STAFF RECOMMENDATION

2618 Barton Avenue

July 21, 2021

Application: New Construction—Addition; Setback Determination
District: Hillsboro-West End Neighborhood Conservation Zoning Overlay
Council District: 18
Base Zoning: RS7.5
Map and Parcel Number: 10411016300
Applicant: Blaine Bonadies, Architect
Project Lead: Sean Alexander, sean.alexander@nashville.gov

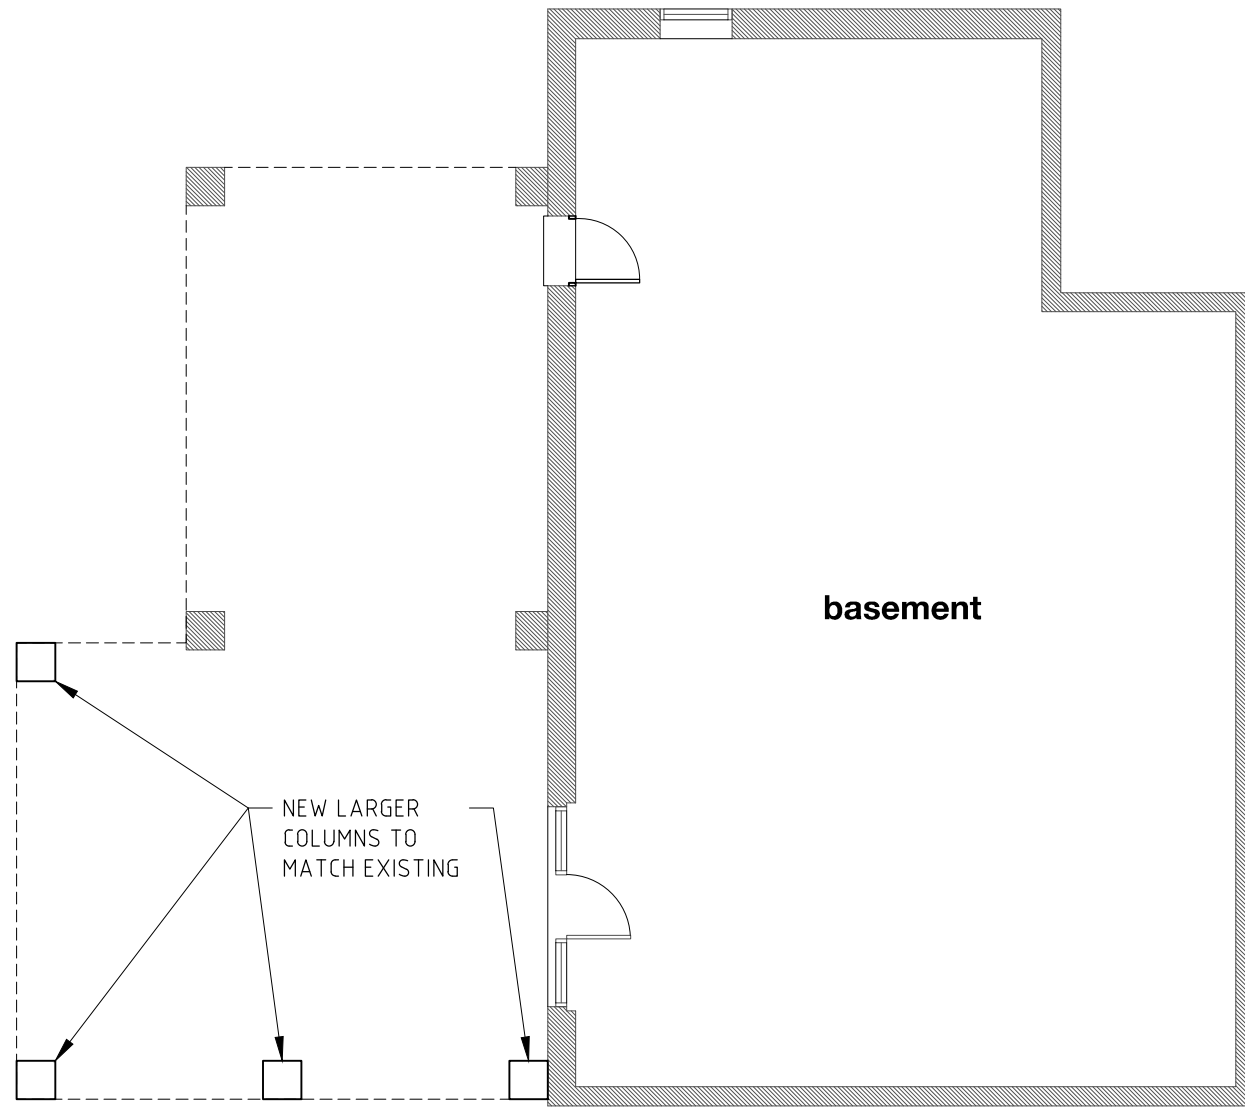
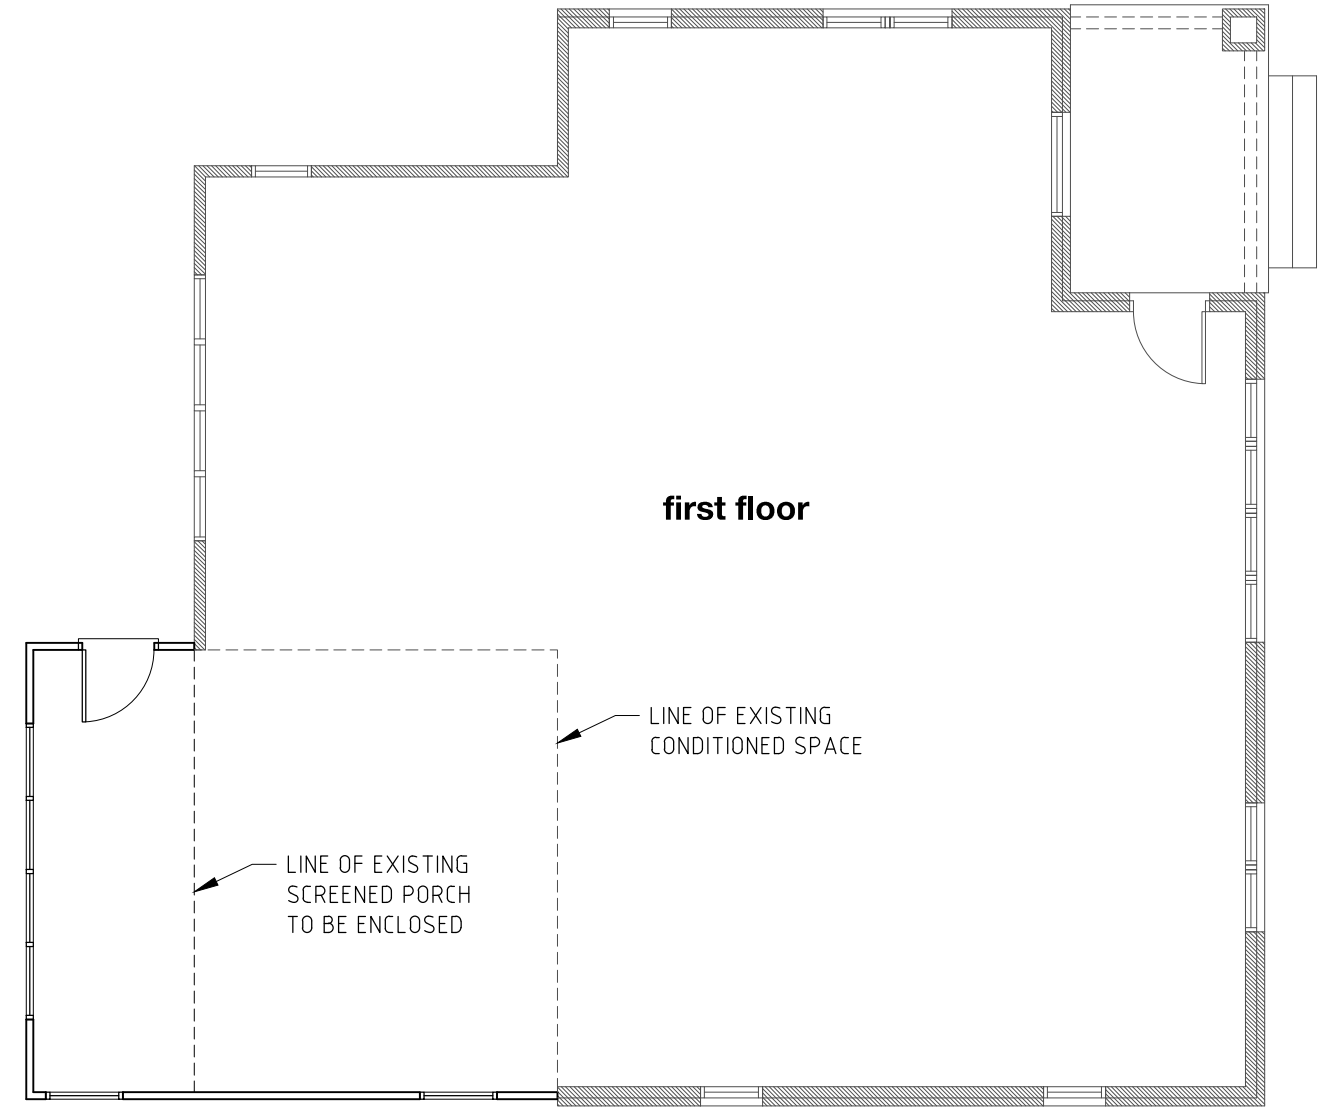
Height & Scale: The first story of the addition encloses an existing porch and extends a portion of the footprint six feet (6') to the rear, whereas the design approved by the MHZC in June was to extend three feet (3') to the rear. Also, an uncovered deck accessed from a rear facing door will be accessed from a side-facing door on an interior wall. The new design is otherwise identical to the previous plan.

Setback & Rhythm of Spacing: The existing house sits approximately two feet, six inches (2'-6") from the left-side property line. The addition matches the width of the house on the left side, which results in the addition also being (2'-6") away from the left-side property line. Staff finds this setback to be appropriate because of the location of the historic house. The new design is otherwise identical to the previous plan in regard to setbacks and rhythm of spacing.

Staff finds that the setbacks of the proposed addition are appropriate and meet Section II.B.1.c. of the design guidelines.
